The Corporation of the
Town of Milton
Committee of Adjustment and Consent

Thursday, August 27, 2026, 6:00 p.m.
Council Chambers - In Person

Report To: Committee of Adjustment and Consent

Subject: 1461 Leger Way

ONTARIO AND QUEBEC RAILWAY COMPANY CANADIAN PACIFIC LIMITED
THE CREDIT VALLEY RAILWAY COMPANY

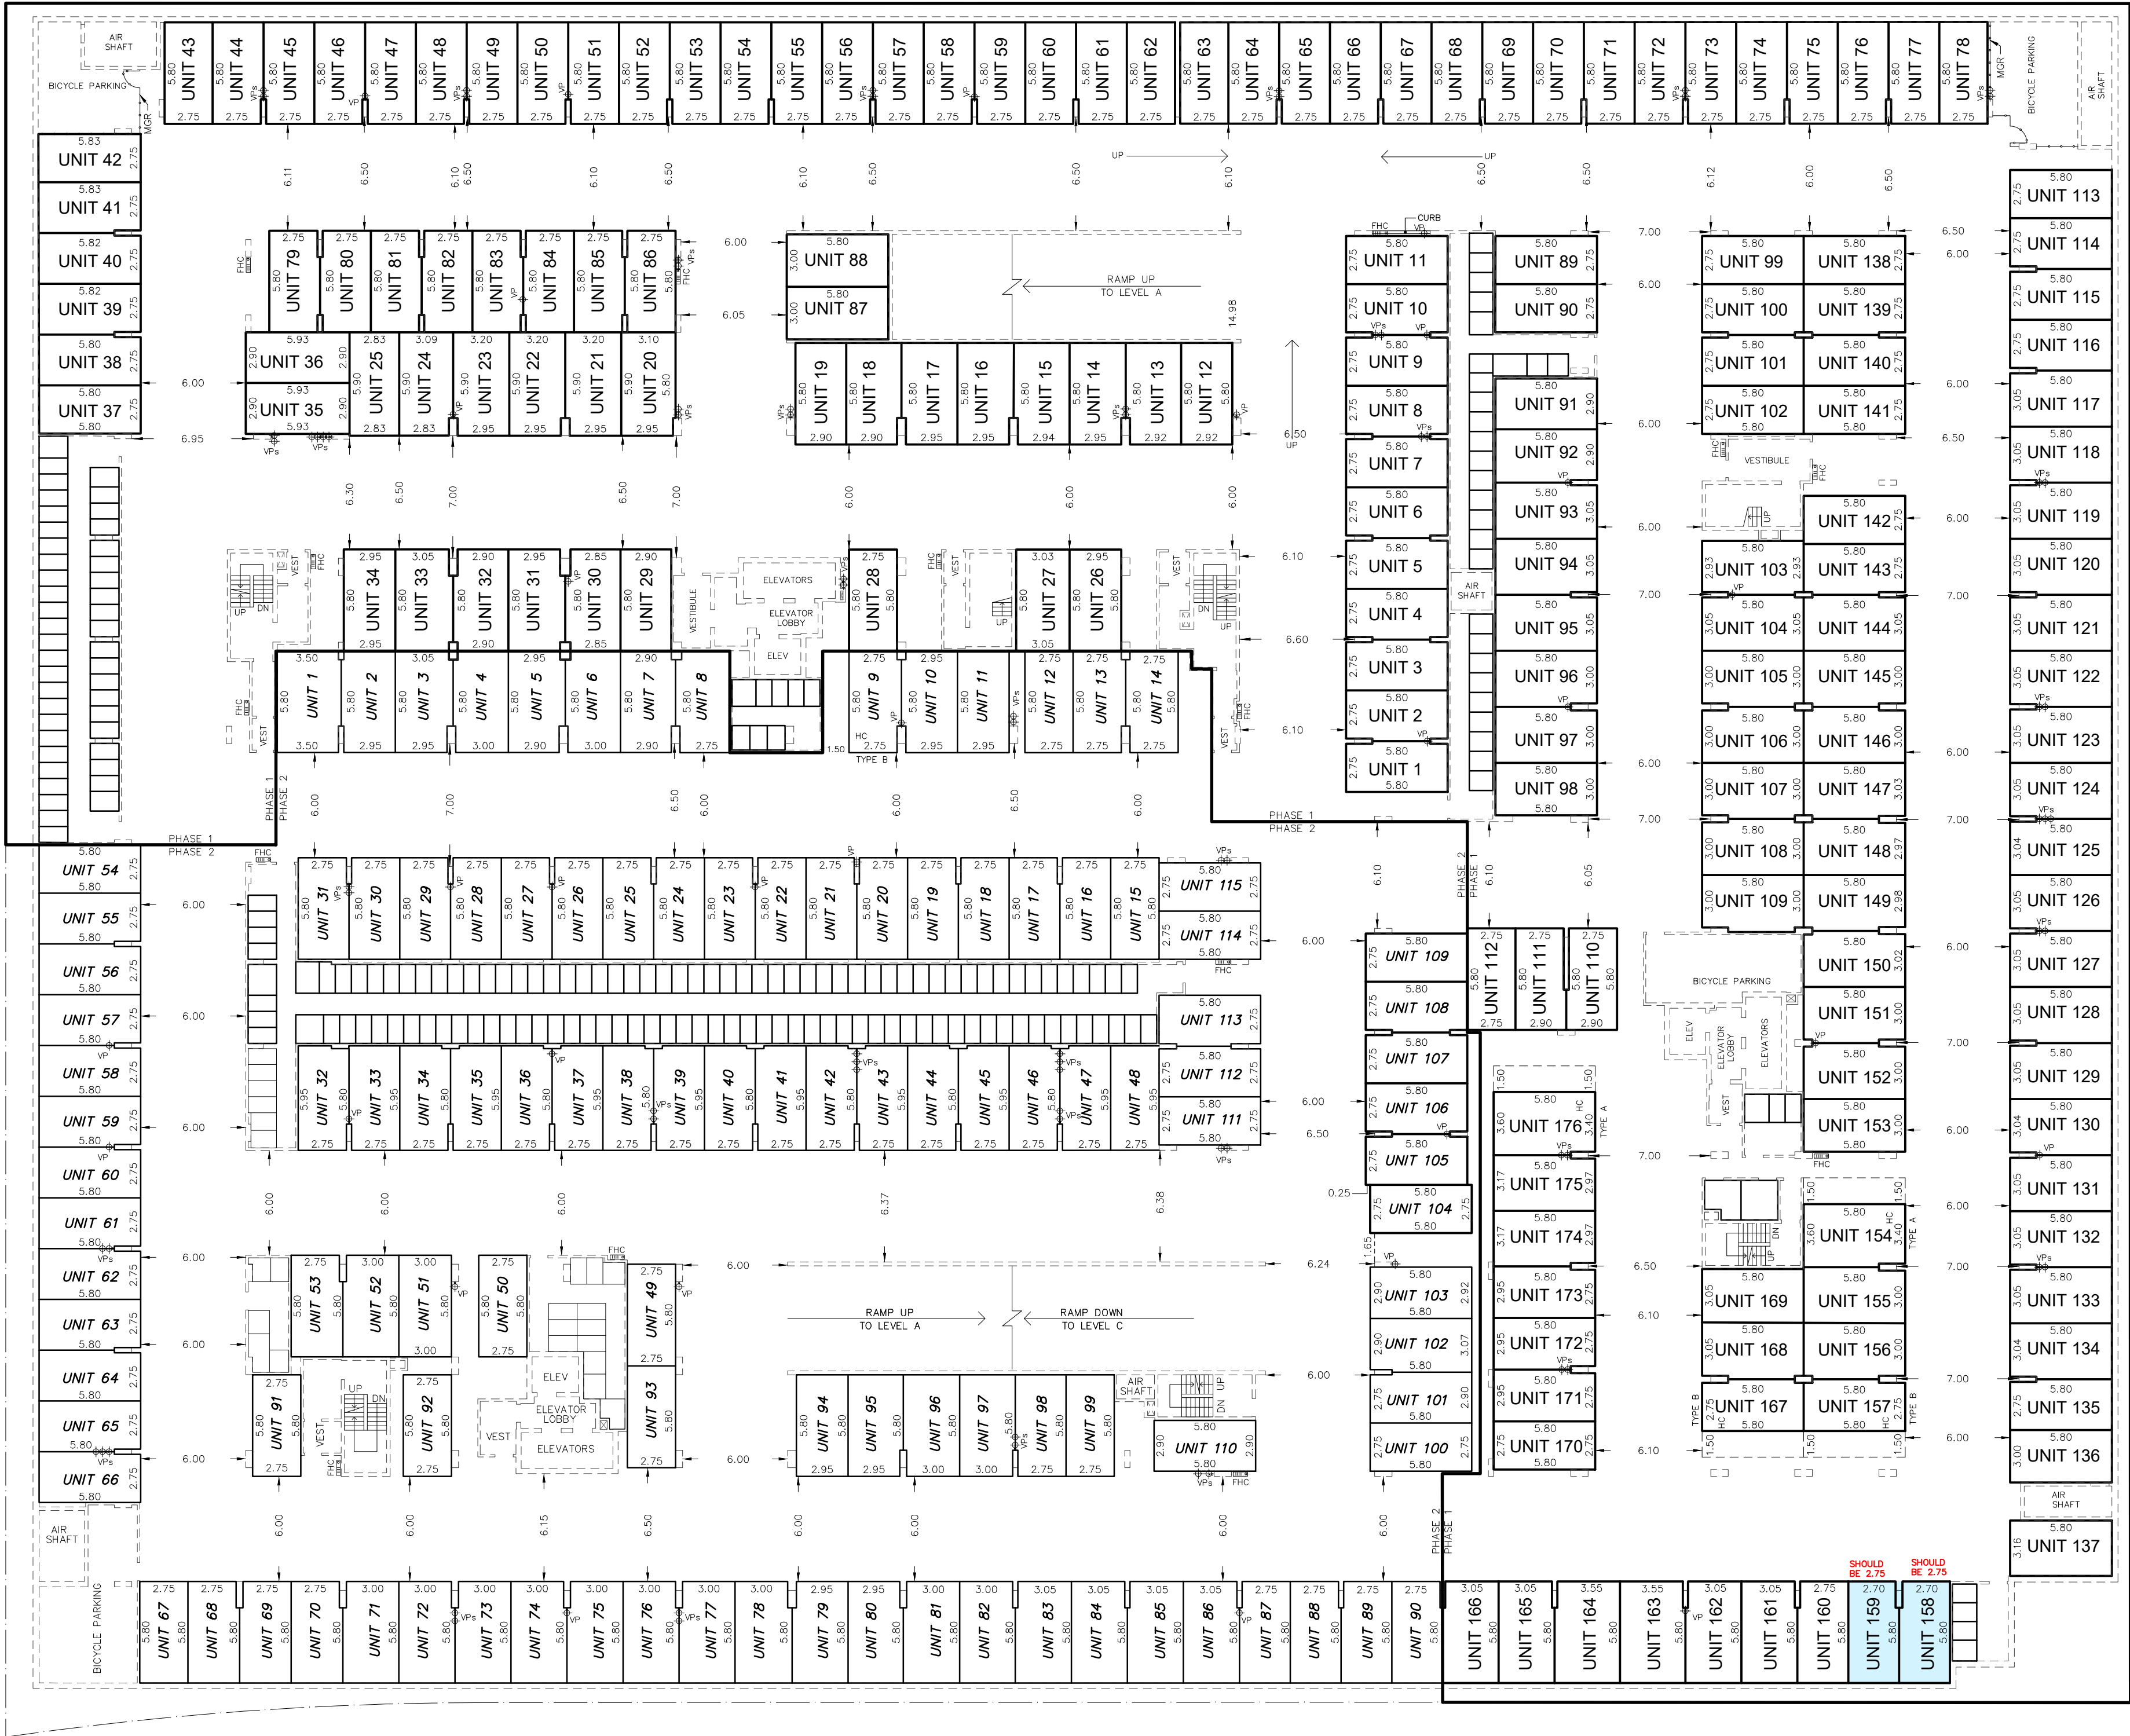
Variance One requests permission for two parking spaces to have a width of 2.7 metres, whereas a minimum width of 2.75 metres is required. The intent of this Zoning By-law provision is to ensure parking spaces are wide enough to permit safe and functional ingress and egress. Transportation staff have reviewed the as-built parking drawings and were satisfied that a width of 2.7 metres would have no impact on the usability or safety of either parking space. In light of this, and considering that the variance seeks a reduction of only 5 centimeters, Planning staff are satisfied that Variance One is minor and maintains the general intent of the Zoning By-law.

As with Variance One, the intent of this Zoning By-law provision is to ensure that parking spaces are long enough to accommodate a vehicle, and allow safe and functional ingress and egress. In this scenario, the requested variance is only required on a technicality, as a length of 5.8 metres is still provided. Transportation staff reviewed the as-built parking drawings and had no concerns with the proposed variance, noting that a vertical clearance of 1.87 to 1.95 metres should still provide sufficient clearance for the vast majority of passenger vehicles. As such, Variance Two is minor and maintains the general intent of the Zoning By-law.

1. THAT the minor variance shall apply in accordance with the as-built parking sketches prepared by KRCMAR and stamped and dated by Town Zoning on July 23, 2026.
2. THAT a redline revision to Site Plan file SP-33/19, reflecting the as-built parking space dimensions, shall be approved within two (2) years of the date of decision;
3. THAT the approval be subject to an expiry of two (2) years from the date of decision if the conditions are not met, if the proposed development does not proceed and/or a building permit is not secured.

**Photographs for Minor Variance Application – Millhouse Condominiums
Nipissing Drive**

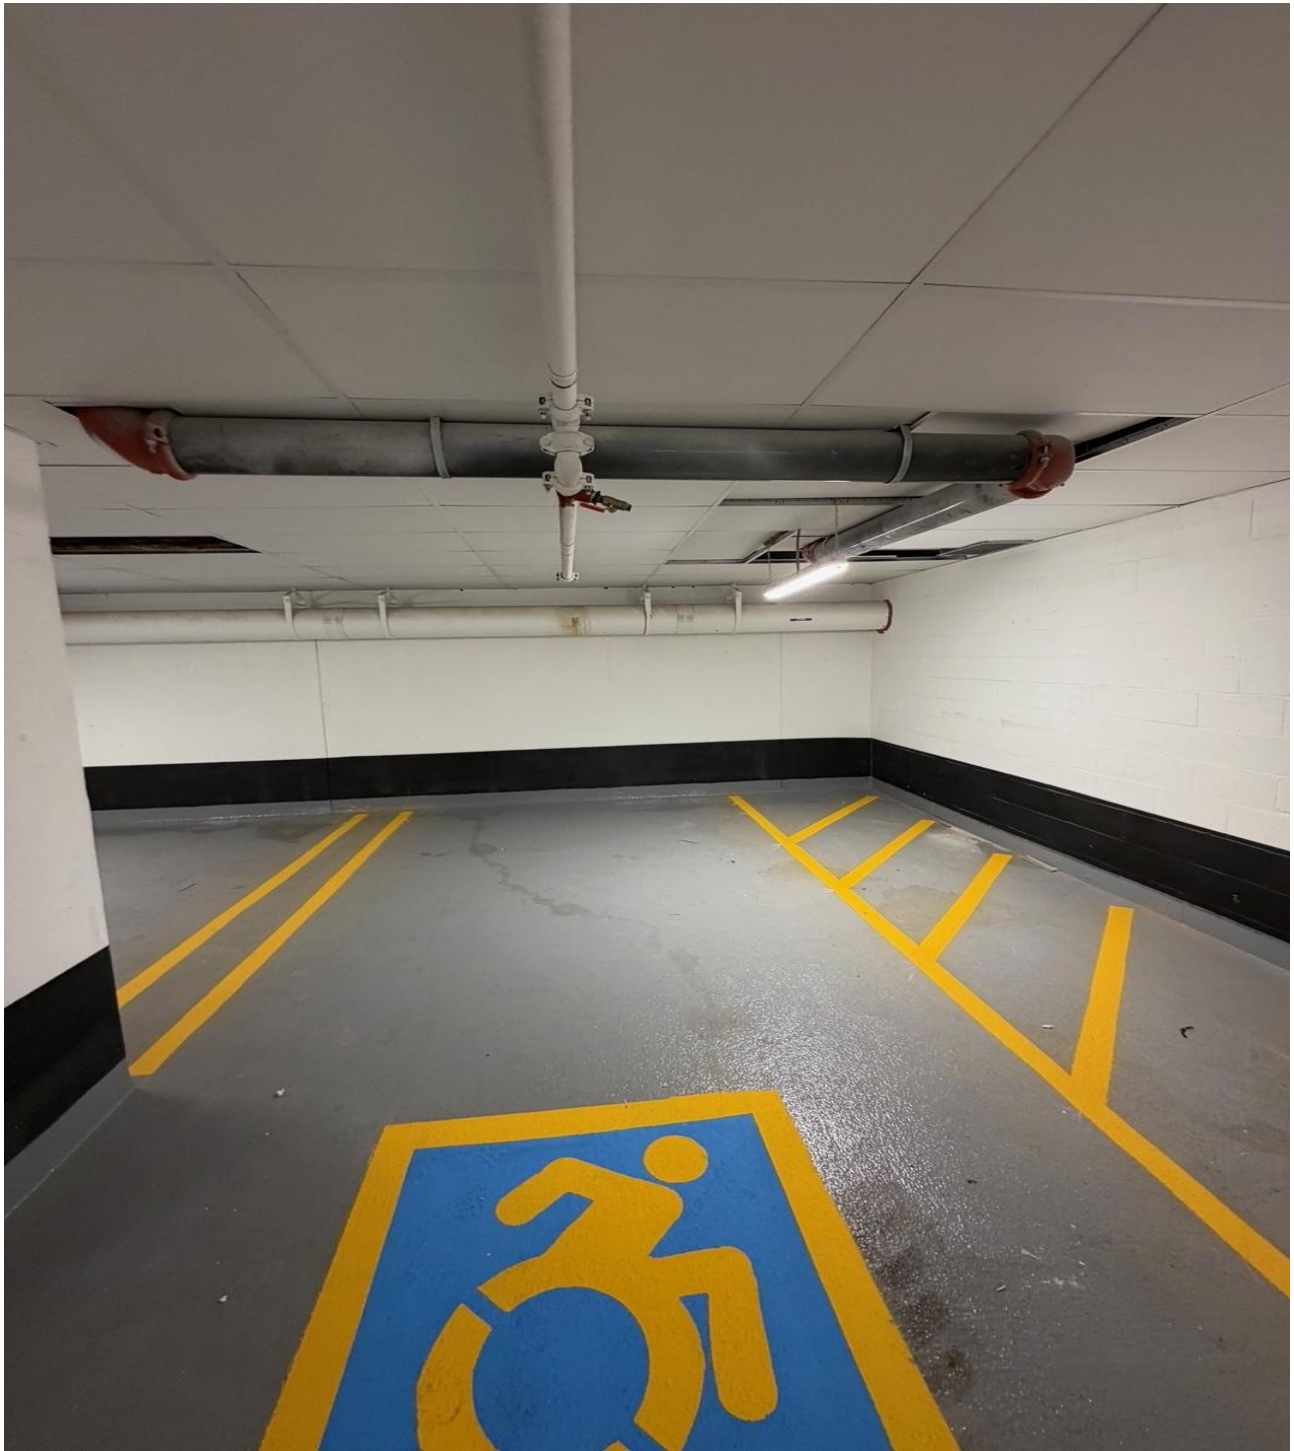
metres can qualify as a parking space. Figure 2 provides a visual reference for the pipe encroachment.

Figure 1 - Architectural Plans

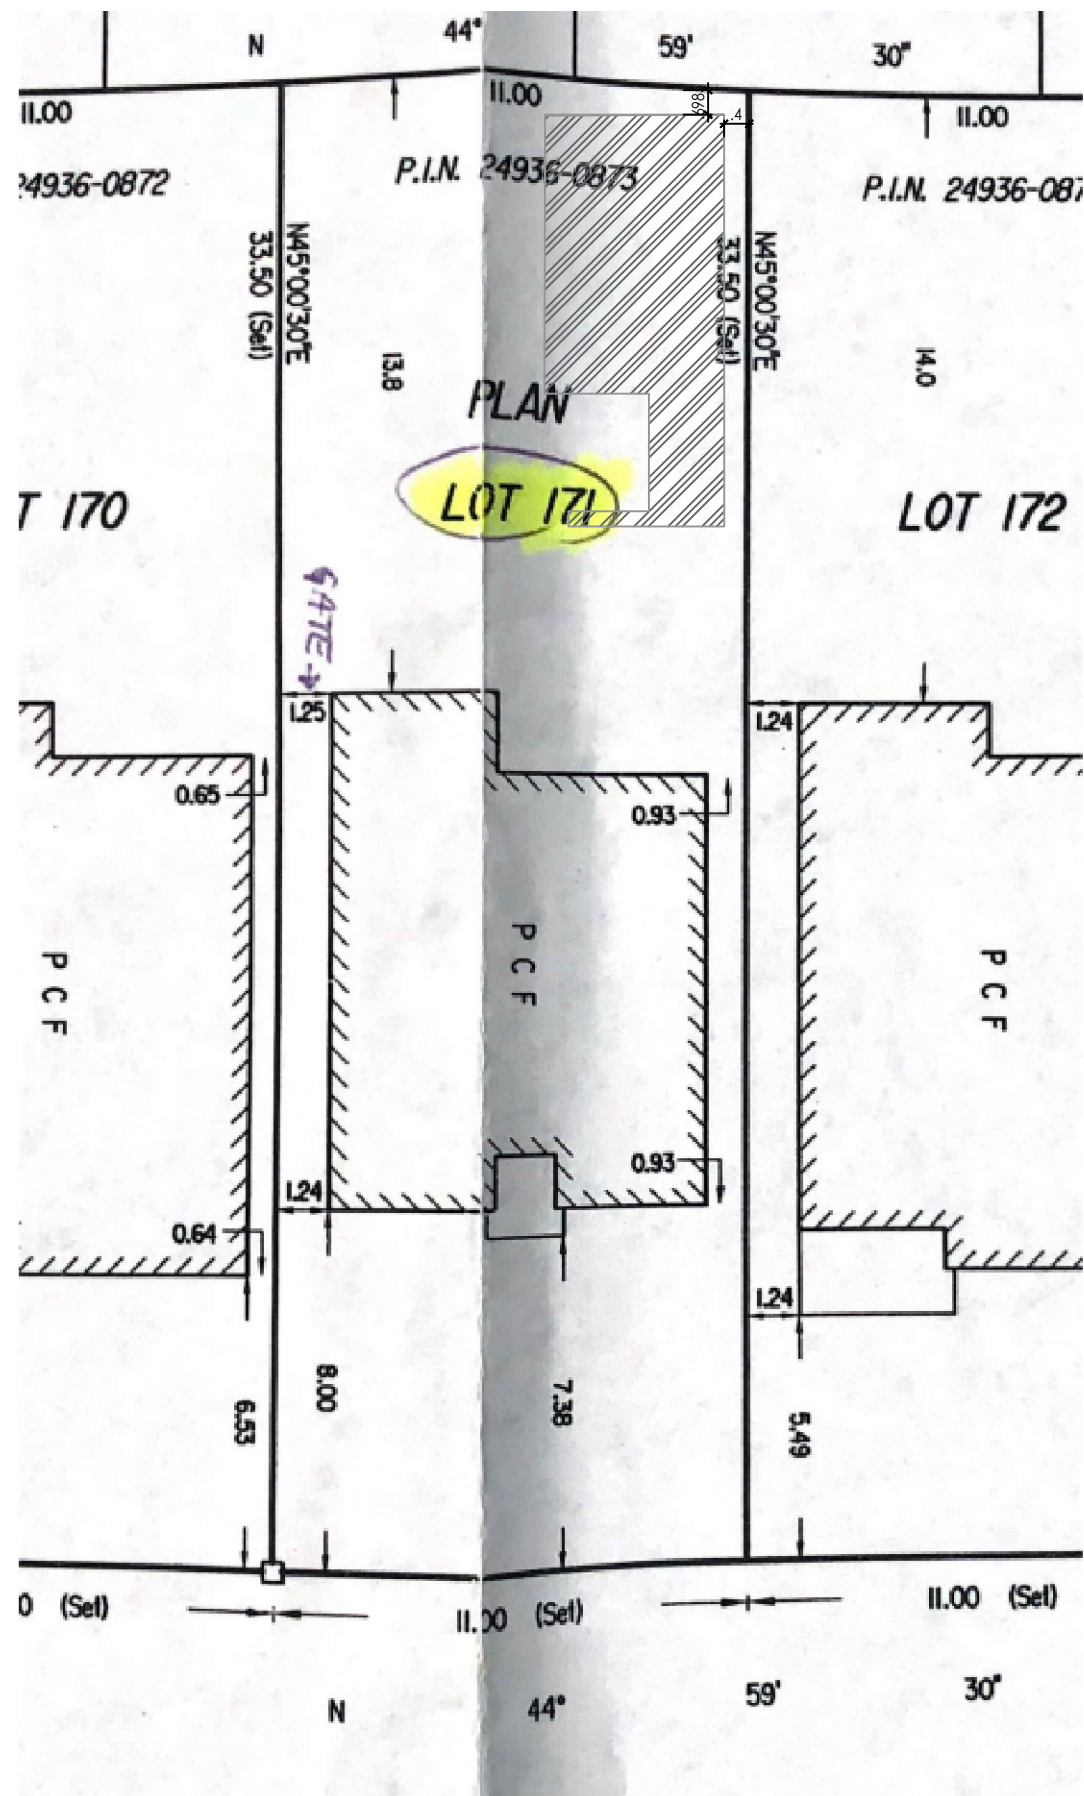
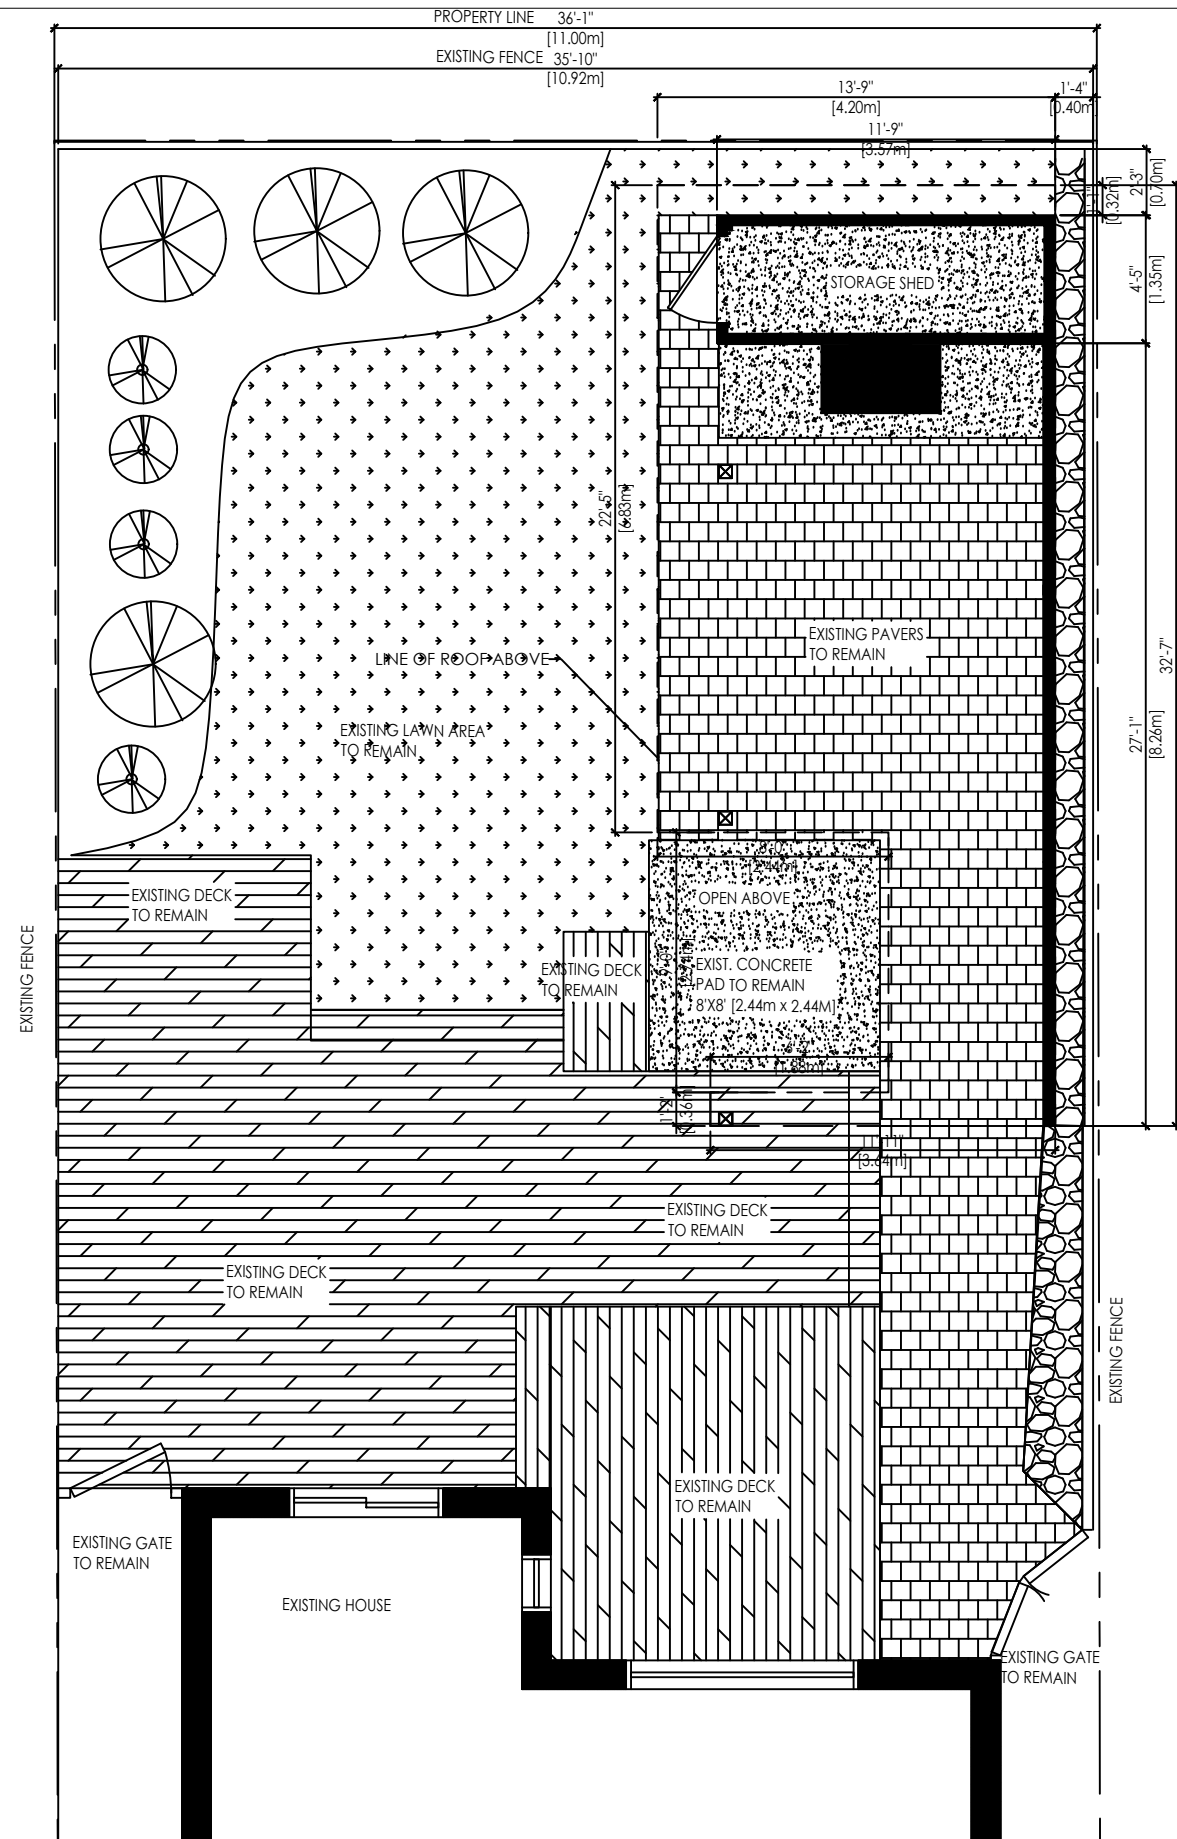
The application seeks to permit the existing accessory structures to be set back of 0.4 metres from the interior side yard, whereas a minimum setback of 0.6 metres is required. The intent of this Zoning By-law provision is to avoid adverse impacts from accessory structures on adjacent properties, and to ensure accessory structures do not interfere with swales or drainage patterns. Given that the accessory structure exceeds the maximum permitted GFA, Planning staff would typically not support a variance of this nature; however, the applicant has provided letters of support from abutting neighbours, including the resident of 1036 Bradley Terrace, whose rear yard abuts the deficient setback. In addition, the applicant has provided as a grading plan which demonstrates that the reduced setback does not have adverse impacts on the Subject Property's drainage pattern. As such, planning staff are satisfied that the variance is minor and maintains the intent of the Zoning By-law.

The accessory structures on the Subject Property have a cumulative GFA of 29.34 square metres, whereas a maximum GFA of 10 square metres is permitted. The intent of this Zoning By-law provision is to ensure accessory structures remain subordinate to the principal dwelling, and to avoid overdevelopment on residential lots. As noted above, Planning staff would typically not support accessory structure GFA of this size coupled with a deficient setback; however, letters of support have been provided from abutting neighbours to address this concern. Planning staff also note that the accessory structures respect the maximum height permissions, and that the amenity structure is only partially enclosed. Staff are satisfied that Variance Two is minor and maintains the general intent of the Zoning By-law.

Variance Three seeks to permit a deck setback of 0 metres to an interior side yard, whereas a minimum setback of 0.6 metres is required. The deck has been in place since 2005. This Zoning By-law provision is meant to ensure stormwater drainage patterns are maintained, and to avoid privacy concerns toward abutting properties. The applicant has provided a grading plan to address Engineering staff's initial concerns, demonstrating that the existing deck has no adverse impacts on drainage. Moreover, the existing deck is relatively low to the ground (with a height of approximately 30 centimeters) and has been in place for two decades without generating any complaints from surrounding residents. As such, Variance Three is minor and maintains the general intent of the Zoning By-law.

1. THAT the development shall be constructed generally in accordance with the site plan dated and stamped by Town Zoning on July 18, 2025;
2. THAT a Building Permit be obtained within one (1) year from the date of the decision;
3. THAT the owner shall obtain an annual Burn Permit from Milton Fire & Rescue Services;
4. THAT the approval be subject to an expiry of two (2) years from the date of decision if the conditions are not met, if the proposed development does not proceed and/or a building permit is not secured.
